Re: Edwards Aquifer, Comal County
NAME OF PROJECT: Heritage Business Park, 1650 and 1672 Independence Drive; New Braunfels, Texas
TYPE OF PLAN: Request for Modification of a Water Pollution Abatement Plan (WPAP); 30 Texas Administrative Code (TAC) Chapter 213 Edwards Aquifer
Edwards Aquifer Protection Program File No. 1814.00, Regulated Entity Reference Number RN102750627 and Edwards Aquifer Protection Program File No. 1605.00, Regulated Entity Reference Number RN102751252

Water Pollution Abatement Plan Modification

HERITAGE BUSINESS PARK WATER POLLUTION ABATEMENT PLAN MODIFICATION

HERITAGE BUSINESS PARK
 ORIGINAL WATERSHED AREAS
 1 OF 1

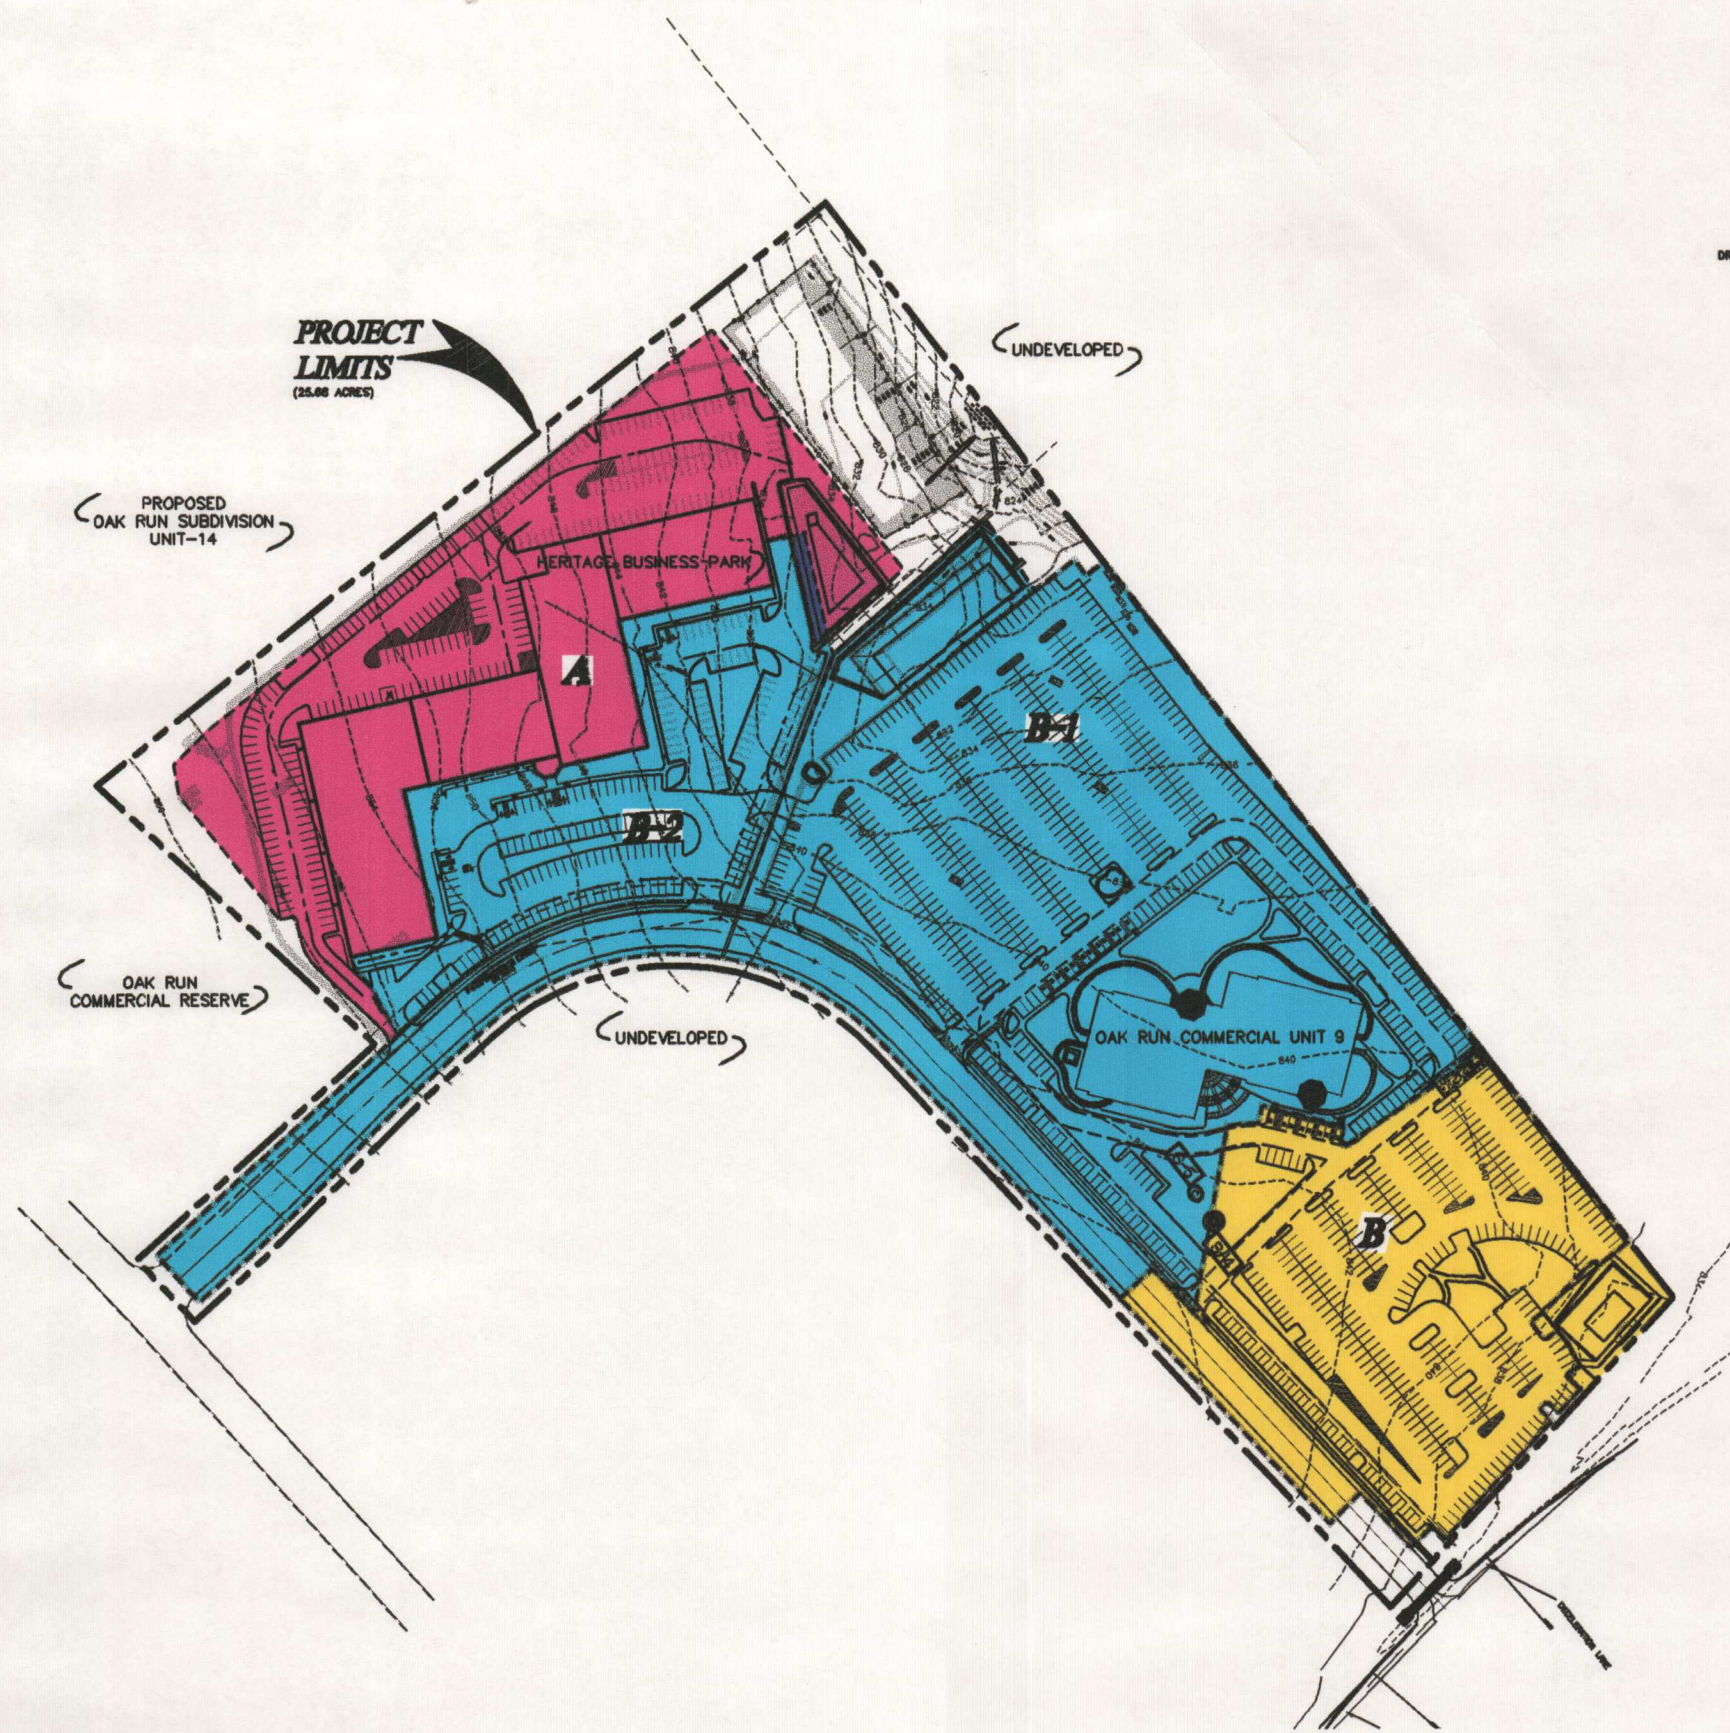
- Runoff from Watershed B-2 (2.68 acres) within the Heritage site is redirected to Basin B-1 within the Oak Run site. This requires the storage volume to Basin B-1 to be increased because the watershed draining to the basin has increased by 2.68 acres. This also results in the storage volume of Basin A to decrease because of the reduction in watershed size.
- Overflow from Basin B-1 is discharged to the creek instead of being sent to the detention basin.
- Upgradient runoff is directed around the Heritage Business Park site and directly into the detention basin. This upgradient runoff is detained in lieu of detaining the on-site runoff.

The attached exhibits show the original and modified watersheds and drainage patterns. Also attached is a summary of design criteria for both water quality basins as approved under the original WPAPs and as proposed in this WPAP Modification.

**HERITAGE BUSINESS PARK
 WATER POLLUTION ABATEMENT BASIN "B-1"**
 SHEET 1 OF 2

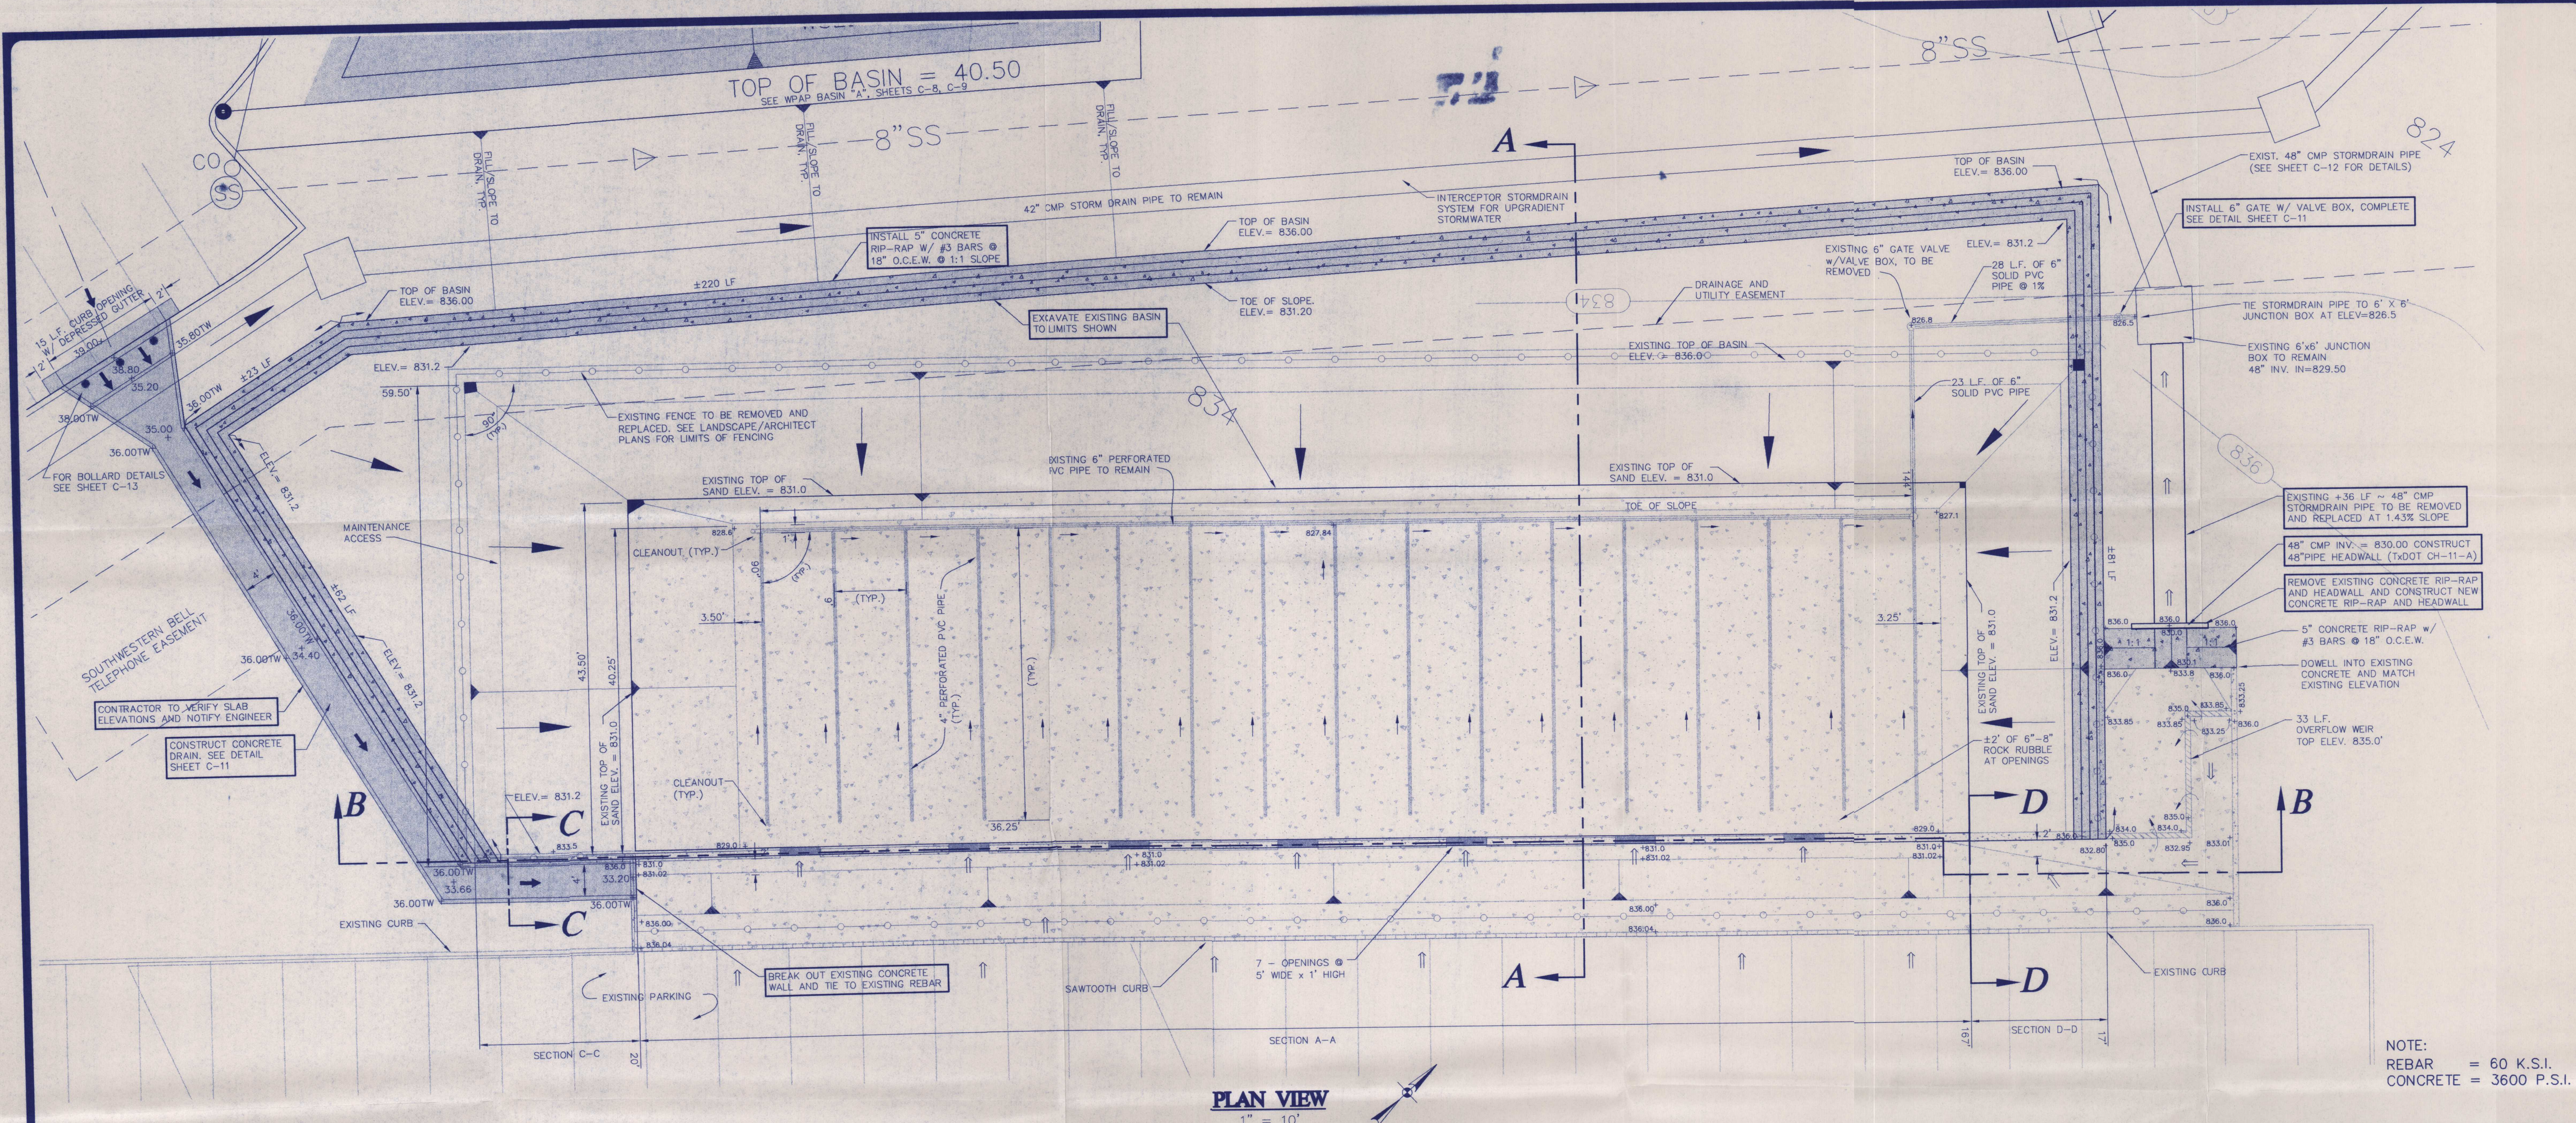
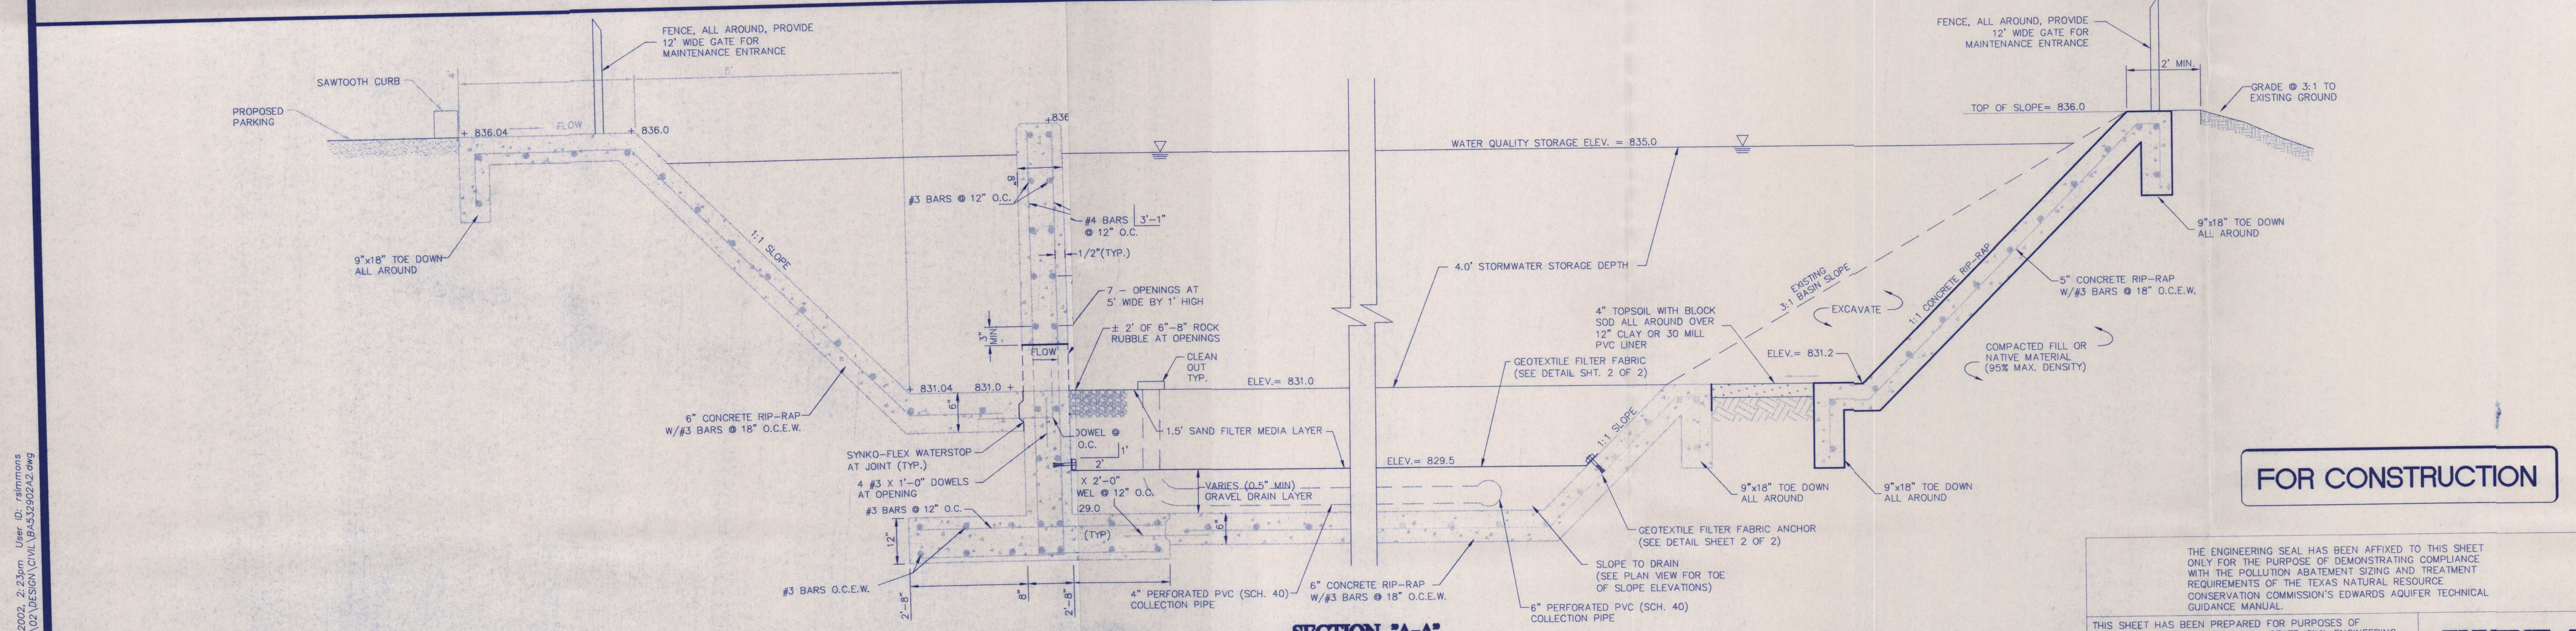
No change in population, water usage, or generation of wastewater will occur as a result of this modification. Land use and site plans remain the same for both commercial sites. Construction on the Oak Run site, Basin B-1, and the detention basin has been completed. Construction of the Heritage site is currently underway. The volume of Basin B-1 will be increased while the basin remains operational in order to continue to provide treatment to the existing Oak Run site. The underdrain system and sand filter will not be altered. The volume of Basin B-1 will be increased by changing the side slopes on three sides of the basin from 3:1 earthen slopes to 1:1 concrete slopes as shown on Exhibit 5.

Basin B-1 from 37,253 cubic feet (CF) to 55,823 CF and the required sand surface area from 3,991 square feet (SF) to 5,981 SF. As originally constructed, the sand surface area provided for Basin B-1 was 7,264 SF and therefore no adjustment to the sand will be required under this modification, only the water quality storage volume will be adjusted. The revision will decrease the required volume of Basin A from 34,897 CF to 25,995 CF and the required sand surface area from 2,908 SF to 2,437 SF. Both sedimentation/filtration basins have been designed to remove 80% of the increased Total Suspended Solids (TSS) for the entire watershed area it is intended to treat in accordance with TNRCC's Technical Guidance Manual RG-348 (1999).

The Texas Commission on Environmental Quality (TCEQ) has completed its review of the request for modification of the approved WPAP for the referenced project submitted to the San Antonio Regional Office by Cara C. Tackett, P.E. on behalf of R.L. Worth & Associates on August 21, 2002. As presented to the TCEQ, the Temporary and Permanent Best Management Practices (BMPs) and construction plans were prepared by a Texas Licensed Professional Engineer to be in general compliance with the requirements of 30 TAC Chapter 213. These planning materials were sealed, signed, and dated by a Texas Licensed Professional Engineer. Therefore, based on the engineer's concurrence of compliance, the planning materials for construction of the proposed project and pollution abatement measures are hereby approved subject to applicable state rules and the conditions in this letter. The applicant or a person affected may file with the chief clerk a motion for reconsideration of the executive director's final action on this Edwards Aquifer protection plan. A motion for reconsideration must be filed no later than 20 days after the date of this approval letter. *This approval expires two (2) years from the date of this letter unless, prior to the expiration date, more than 10 percent of the construction has commenced on the project or an extension of time has been requested.*
